A4018 consultation: report on the results

Introduction: the consultation process

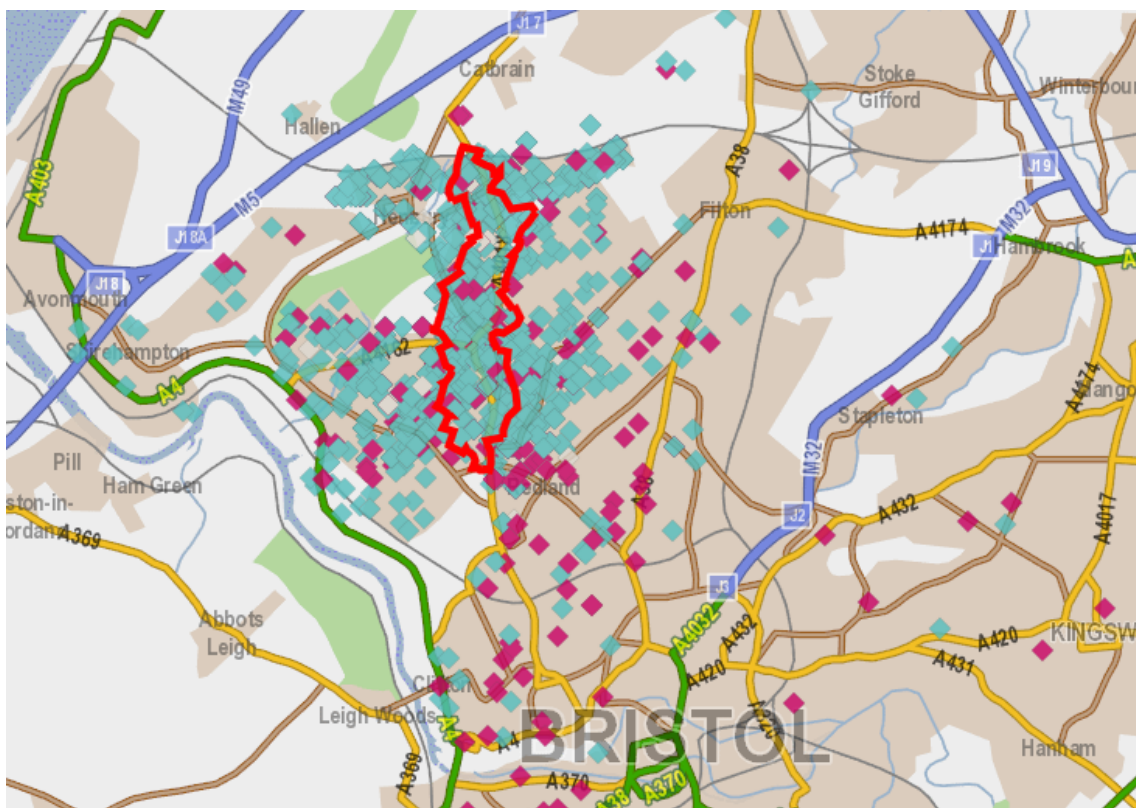
In this example, at Henbury Hill, the proposed prohibited left turn movements out of the side roads have captions. The prescribed 'Ahead Only' movement on the main road is

shown with road markings, arrows and legend. This situation occurred in more than one location.

It was pointed out on the day the consultation launched that this distinction could be considered unclear. By Wednesday 6 February, the third day of consultation, clarification was added to the consultation website in the form of a list of all prohibited and prescribed movements. This list was also put into letter form and, towards the end of February, sent to all 4,700 addresses that had received the original leaflet.
